LINCOLN CITY/LANCASTER COUNTY PLANNING STAFF REPORT

P.A.S.#: Co Special Permit #190, Prel. Plat #01018
Deer Field Community Unit Plan

County Preliminary Plat #01018
County Special Permit #190
Hwy 77 & Martell Rd.
Deer Field

RE: DEER FIELD - PRELIMINARY PLAT & COMMUNITY UNIT PLAN

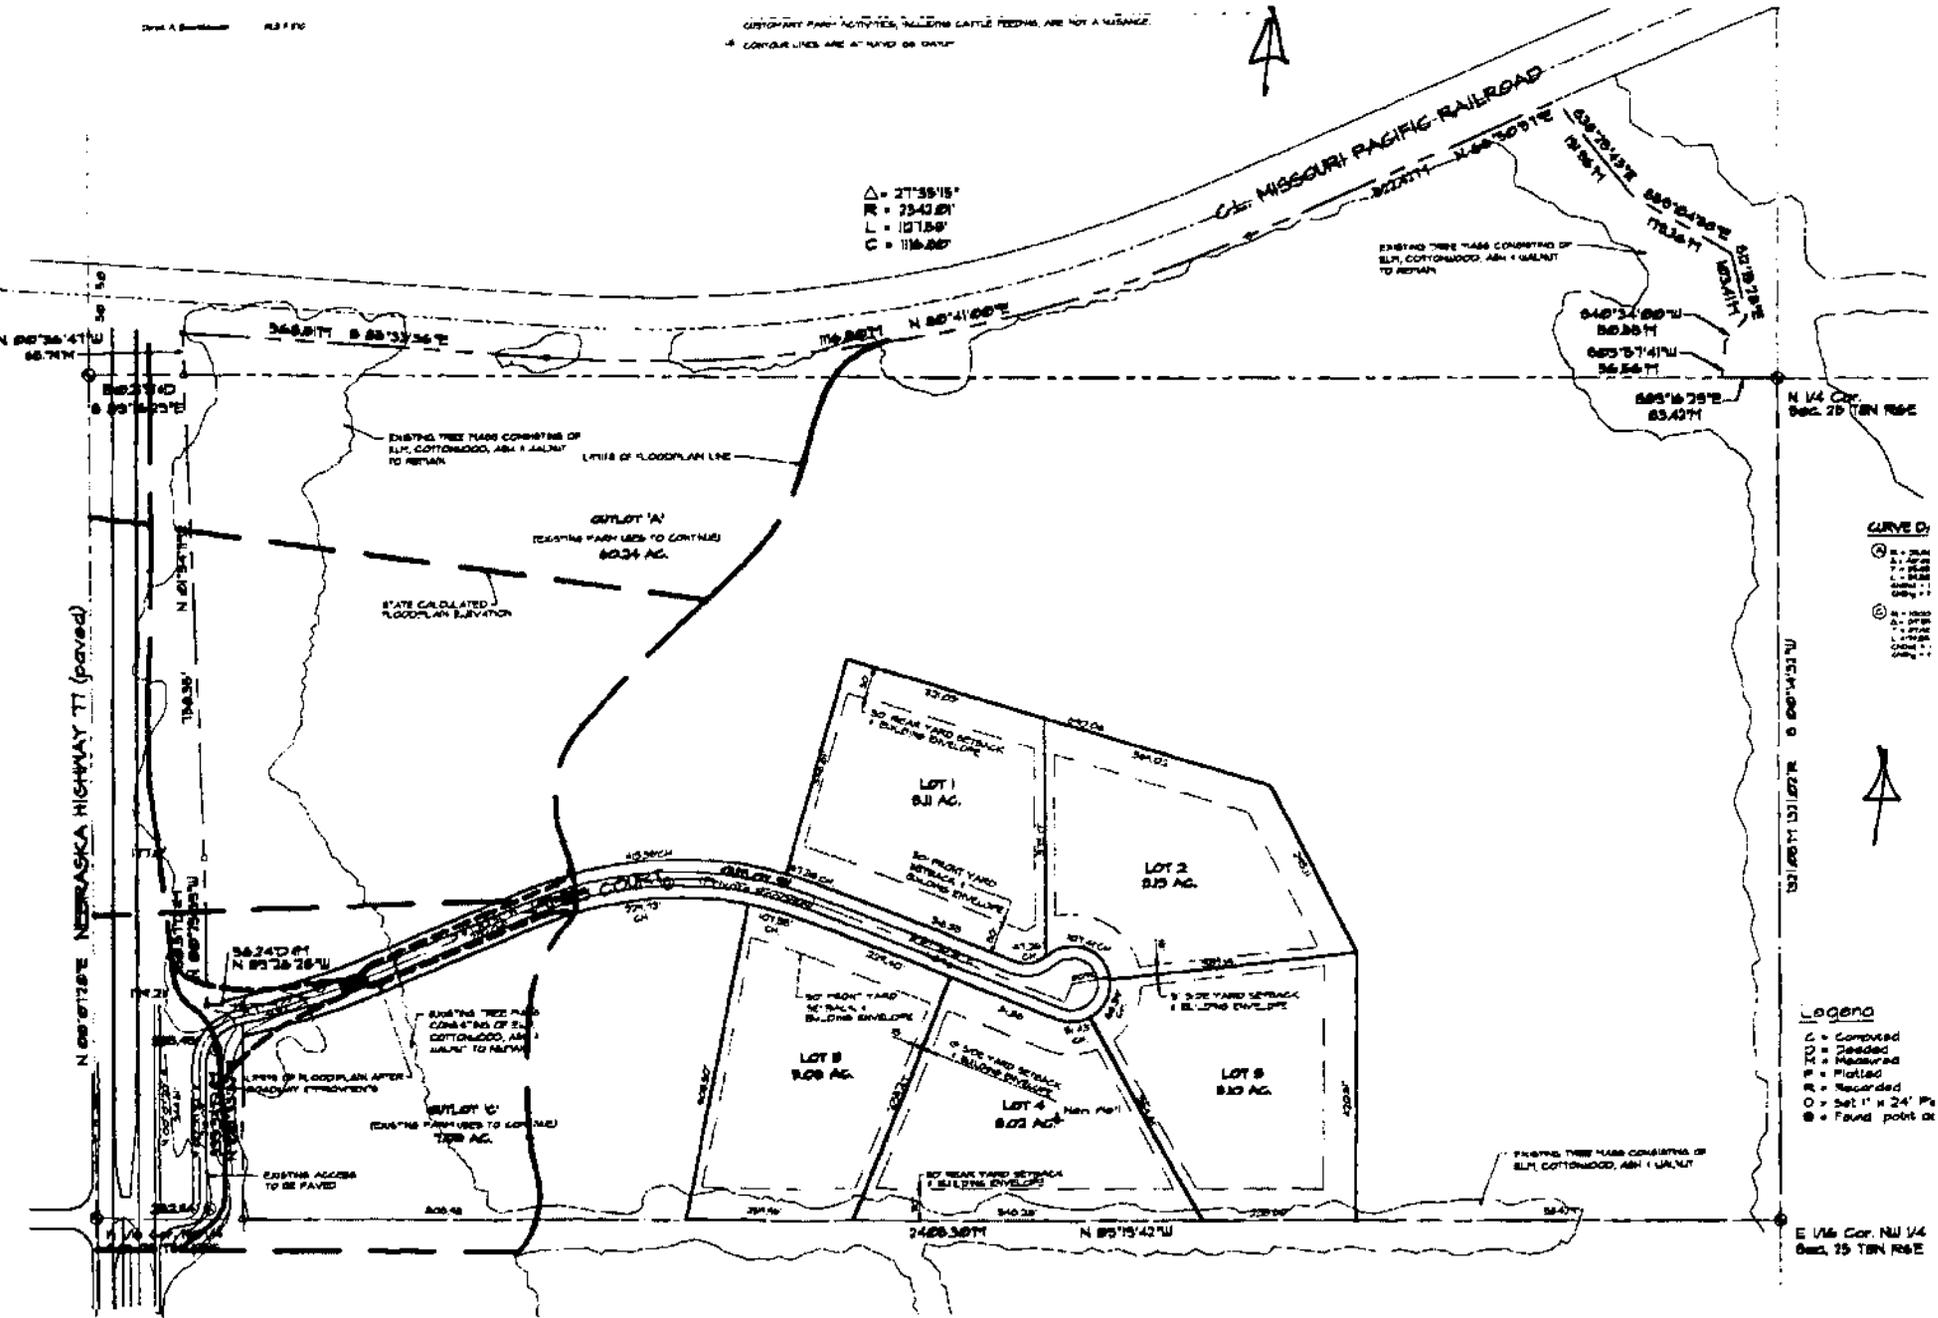
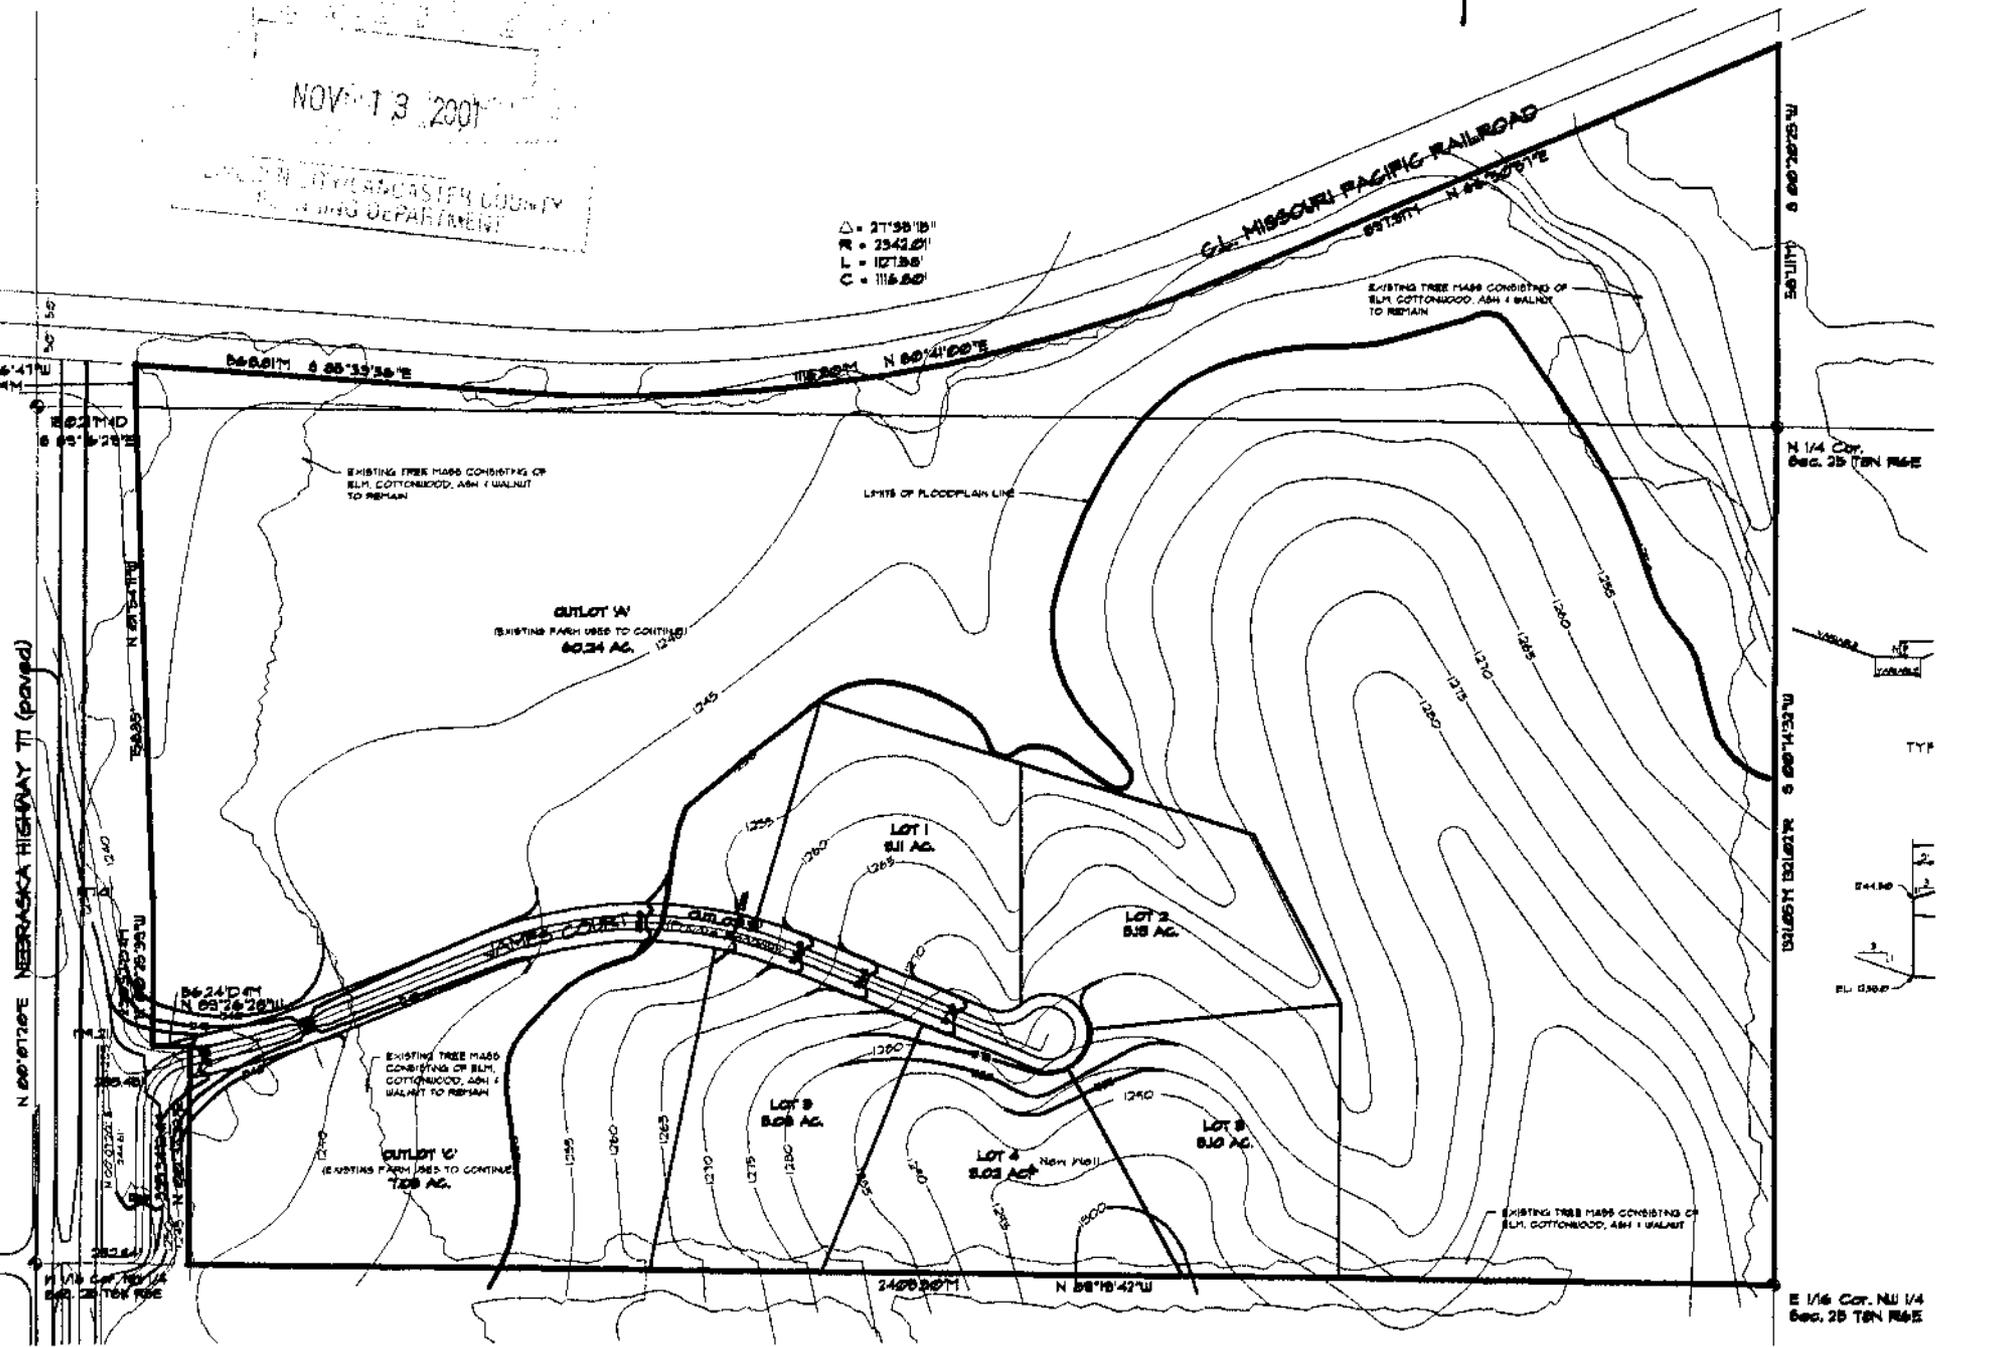
- 1) The typical section for James Court shall not be modified for the length over the drainage structures.
- 2) The profile of James Court does not match the proposed profile used in the hydraulic study nor does the proposed culverts on the Drainage Plan match the hydraulic study.

- 3) The slopes shown on the profile are incorrect between Sta. 1+00 and Sta. 12+50.
- 4) The *100 Year Flood* water surface elevations in the hydraulic study are 1,245.6 and 1,246.2 for Alternates 1 and 2 respectively. The *100 Year Flood* water surface elevation is shown as 1,250 on the Grading Plan. This discrepancy must be resolved.

- 5) The radii shown for Curves A and B are acceptable provided James Court remains a private roadway. This office would highly object to any future dedication of James Court as a public road.

- 6) A Flood Plain Permit will be required for the proposed road and culverts.
- 7) Input is needed from the Nebraska Department of Roads for this development. A southbound left-turn lane on Highway 77 may be needed.

1. While a westerly part of this plat is within the 100 year flood plain, how was the shown flood plain limit determined?
2. General Note No. 14 should also provide that the lowest floor elevation and any opening shall be certified as 1 foot above the determined flood plain elevation, during the building construction process.
3. While the public road along the west side of this property is designated as U.S. Highway 77, the street name is South 12th Street.

- 1.1 Make the corrections requested by the County Engineer in his letter of November 19, 2001.
 - 1) The typical section for James Court shall not be modified for the length over the drainage structures.

- 2) The profile of James Court does not match the proposed profile used in the hydraulic study nor does the proposed culverts on the Drainage Plan match the hydraulic study.

- 3) The slopes shown on the profile are incorrect between Sta. 1+00 and Sta. 12+50.
 - 4) The 100 year flood water surface elevations in the hydraulic study are 1,245.6 and 1,246.2 for Alternates 1 and 2 respectively. The 100 Year Flood water surface elevation is shown is 1,250 on the Grading Plan. This discrepancy must be resolved.

- 5) The radii shown for Curves A and B are acceptable provided James Court remains a private roadway. this office would highly object to any future dedication of James Court as a public road.

- 6) A floodplain permit will be required for the proposed road and culverts.
 - 7) Input is needed from the Nebraska Department of Roads for this

development. A southbound left-turn land on Highway 77 may be needed.

- 1.2 Note all requested waivers.
- 1.3 Note the rail line is abandoned.
- 1.4 Correct the legal description on the plat and the acres shown on note #1.
- 1.5 Revise the subdivision boundaries shown to exclude Lot 7 IT.

- 1.6 Show the western tree mass and water way to be preserved.
- 1.7 Show the easements requested by Norris Public Power.
- 1.8 Show a vicinity map.
- 1.9 Revise the Subdivision name of Deerfield. A subdivision of that name already exists at north 27th and Center Road

- 1.10 Revise the Street name of James Court on sheets 1 and 2.
- 1.11 Revise the approval/acceptance blocks to show the year 2002.
- 1.12 Note the comments from the NRD.

- 1.13 Extend James Court to the east edge of the acreage lots so it can provide access to the east in the future. Add a note that at such time as development to the east occurs, James Court will be extended.

- 1.14 Show a future road extension/projection to the south and provide a street stub for its location.
- 1.15 The lot line between Lots 1 and 2 should be perpendicular to the street.

- 1.16 Show the locations and direction of flow of the water courses.
- 1.17 Amend the street name of Hwy 77 to include So. 12th Street.
- 1.18 Note the source determination of the floodplain shown.

- 1.19 Amend Note #14 to provide that the lowest floor elevation and any opening shall

be certified as 1 foot above the determined flood plain elevation, during the building construction process.
